LONG BEACH CITY COLLEGE DISTRICT
CONTRACTS MANAGEMENT DEPARTMENT

BID C2194 BUILDING MM CONSTRUCTION TRADES 1 MODERNIZATION PROJECT AT THE PACIFIC COAST CAMPUS

ADDENDUM NO # 1

JULY 6, 2020

SHEET NUMBER
C6.00 1

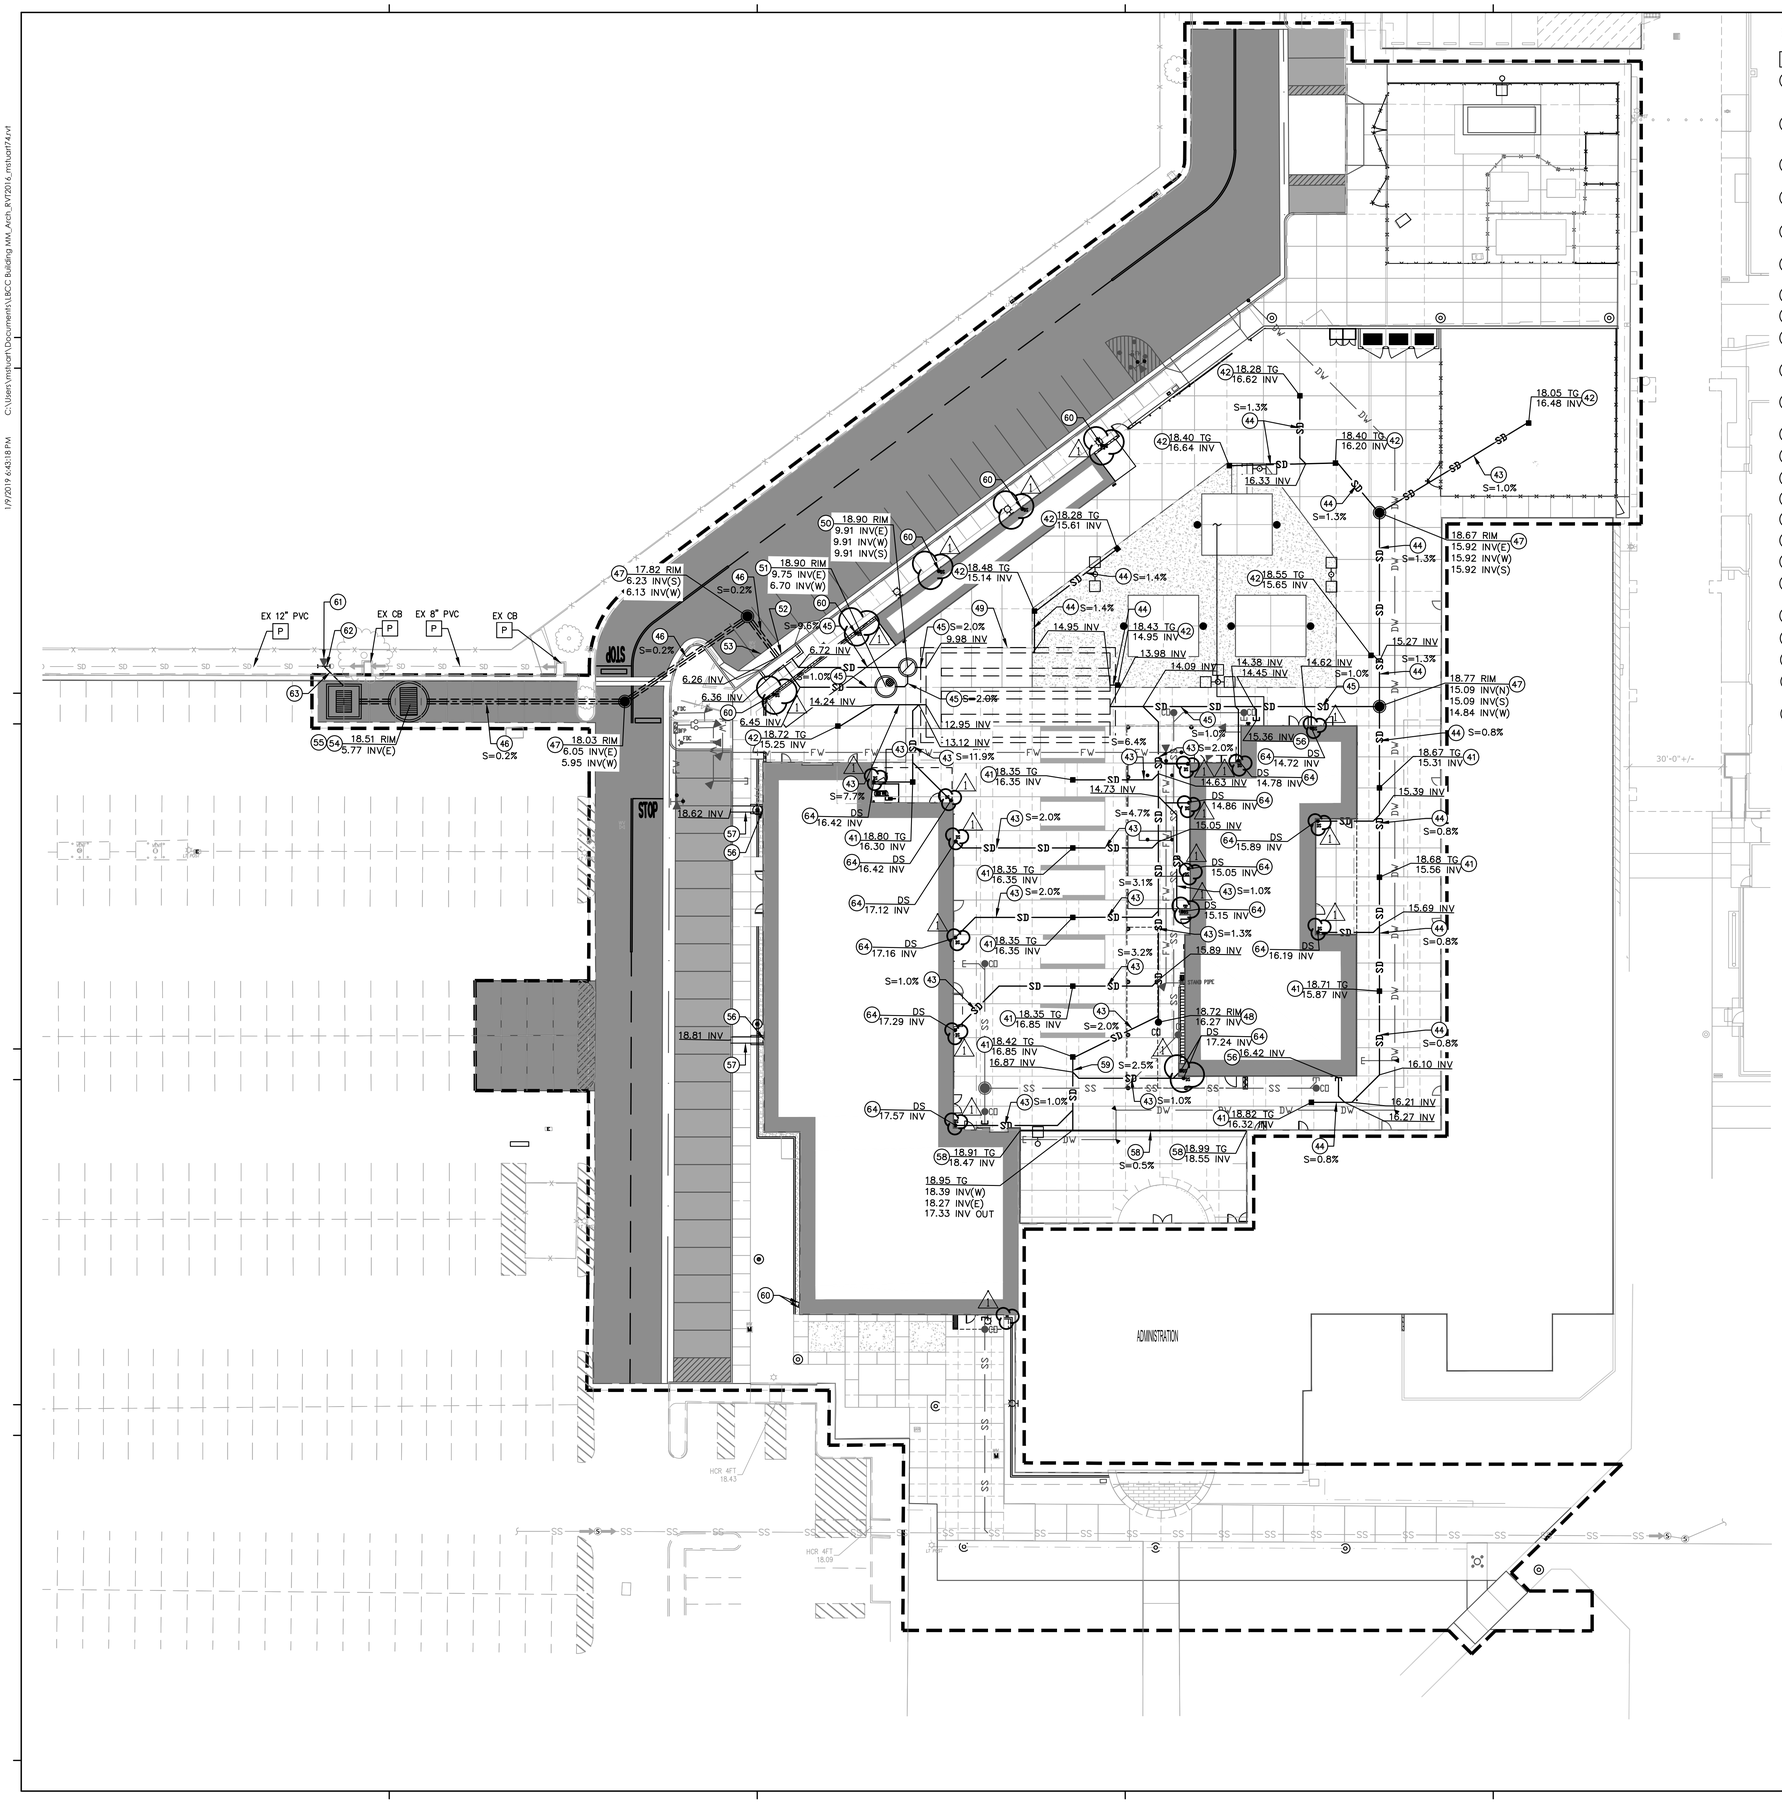
13.	Civil	C5.20	Added and fixed misc. elevations (not clouded for plan clarity)	Yes
14.	Civil	C5.30	Added and fixed misc. elevations.	Yes
15.	Civil	C6.00	- Added downspout locations. - Added and fixed misc. elevations (not clouded for plan clarity) - Coordinated inlets of Contech per C1/C9.10 (not clouded	Yes

for plan clarity)	
16.	Civil	C7.00	Revised footprint of new storage building.	Yes
17.	Civil	C7.10	- Revised footprint of new storage building. - All utilities not related to civil unreferenced on the plans except for structures that can be seen on the surface (i.e. lights, pull boxes, vaults, etc.) (not clouded for plan clarity) - Fixed and added to keynote 76.	Yes

SITE PLAN -ENLARGED TRASH COMPACTOR | SCALE 1" = 10'-0" | 1

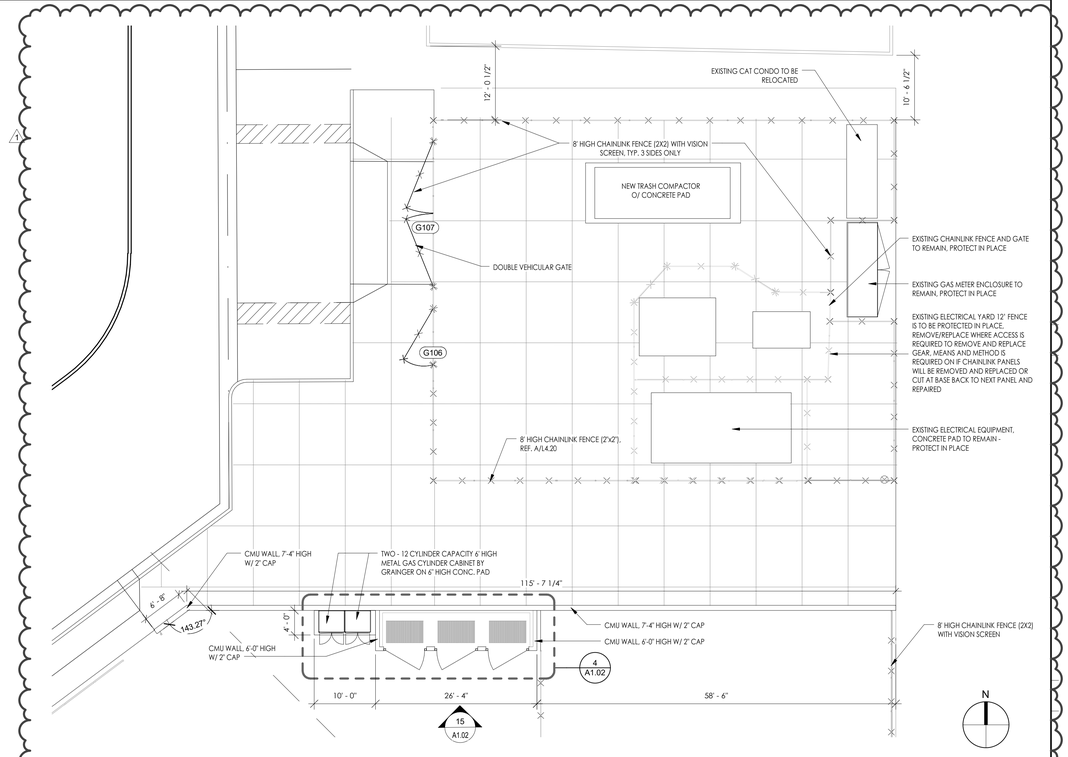
41.	Architectural	A1.02	- 1/A1.02: Added dims and revised note at existing chain link fence. - 2 & 18/A1.02: Revised CMU cap detail. - 4/A1.02: Added dims for concrete pad and specified anchors for gas cylinder cabinets. - 5/A1.02: Provided heavy duty casters for swing gates.	Yes

ENLARGED PLAN - WEST CANOPY @ (N) WORKSHOP BUILDING — SCALE 3/16" = 1'-0" — 25

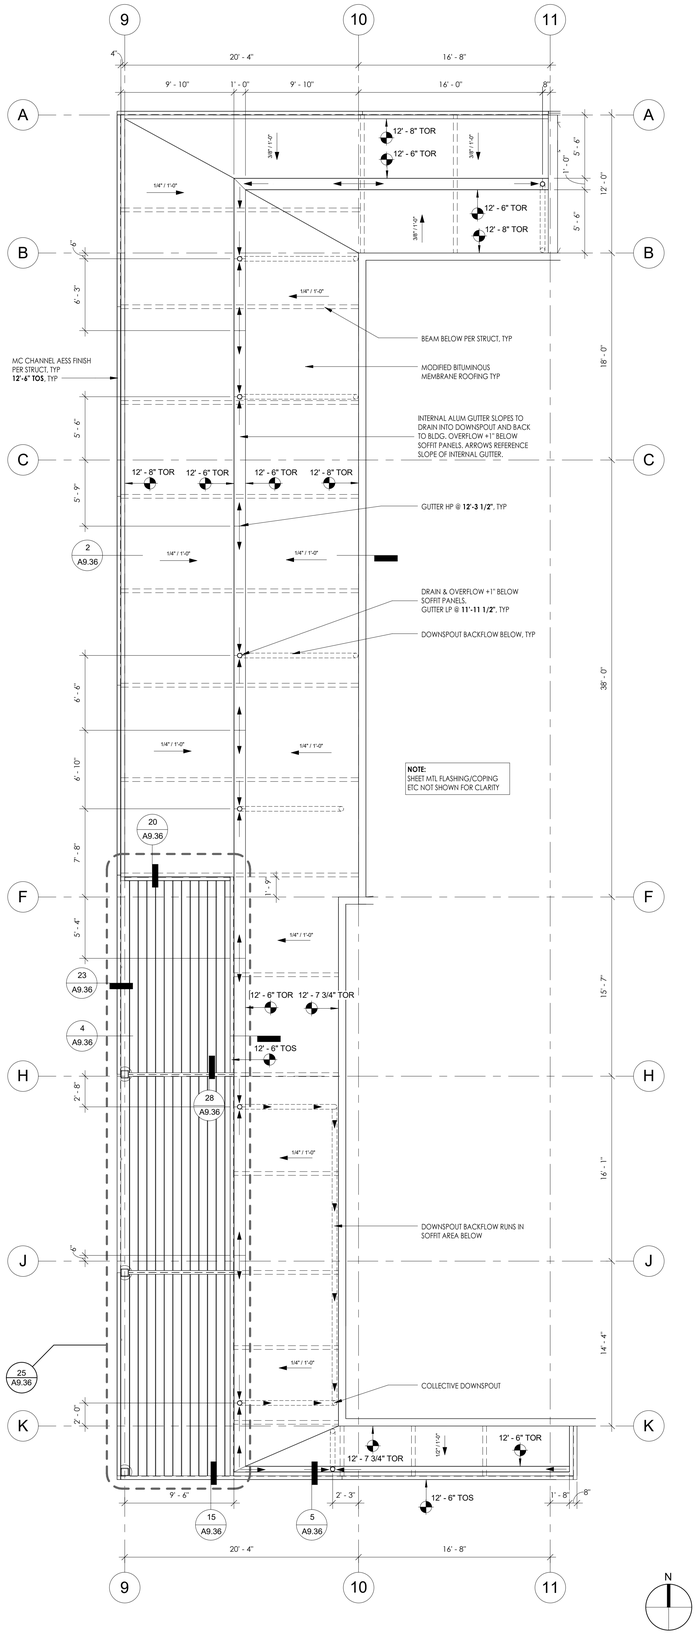
51.	Architectural	A2.31	- Revised TOR dims. - Revised walk pad route. - Revised roof drainage at GL B/12 - Added downspouts, high points & low points at canopy gutter. - Added 10 & 25/A2.31 (enlarged canopy plans)	Yes

1 12KV SINGLE LINE DIAGRAM - DEMO

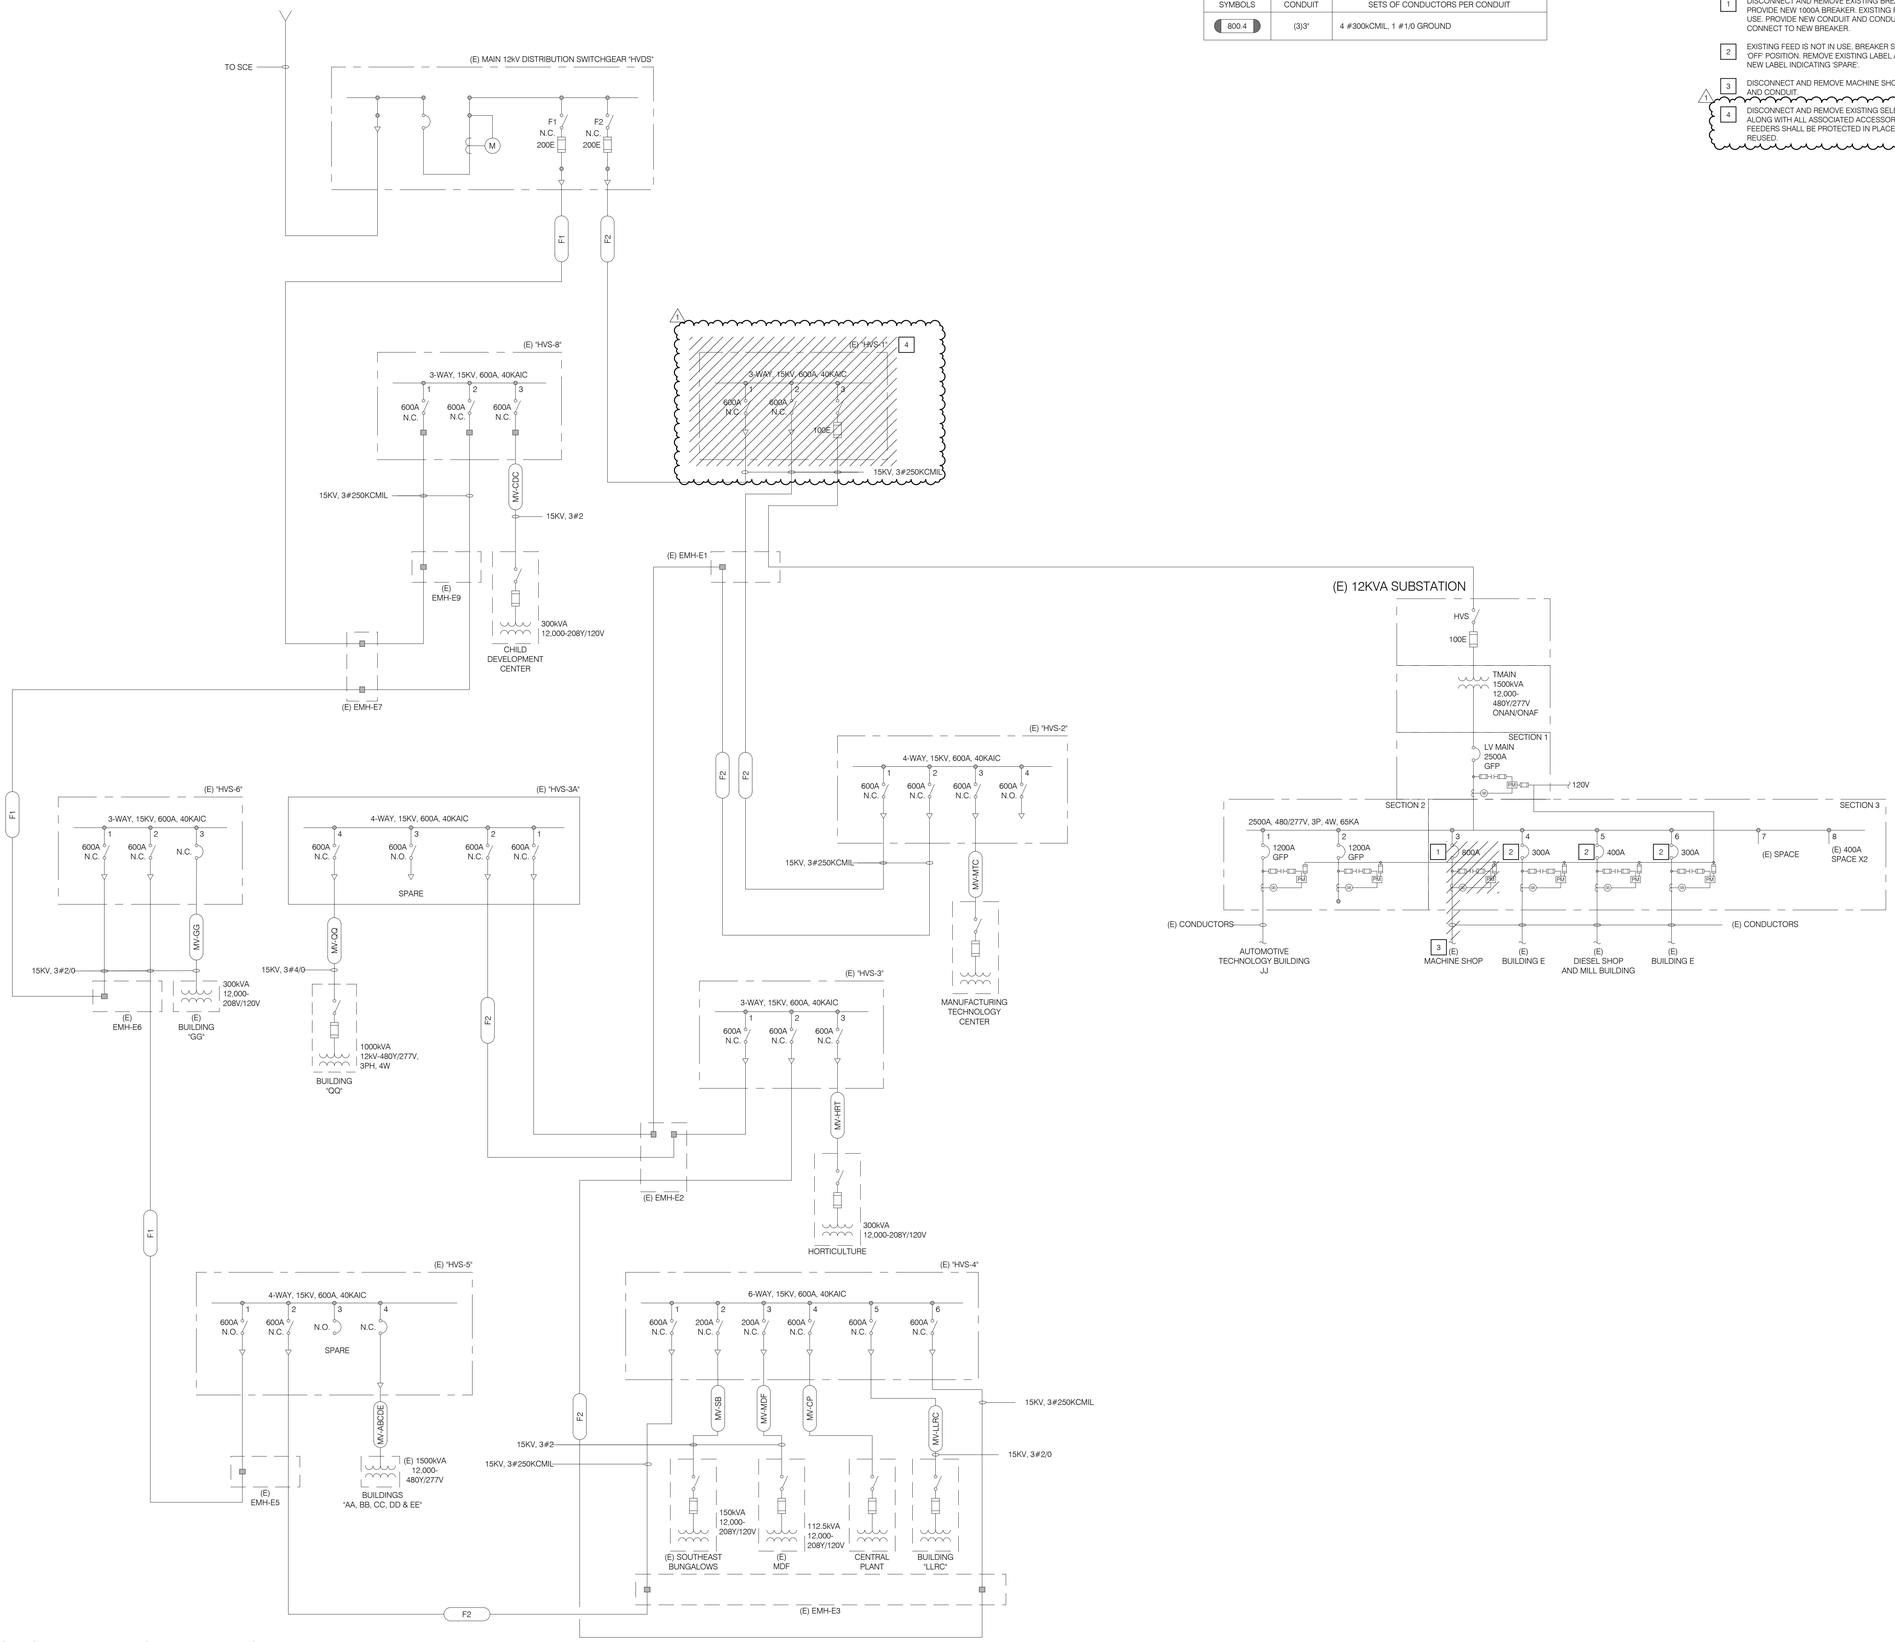
117.	Electrical	E3.2	Projector removed; flat panel displays added.	Yes
118.	Electrical	E3.3	Flat panel display added.	Yes
119.	Electrical	E5.1	MV single line updated to include removal of existing selector switch.	Yes
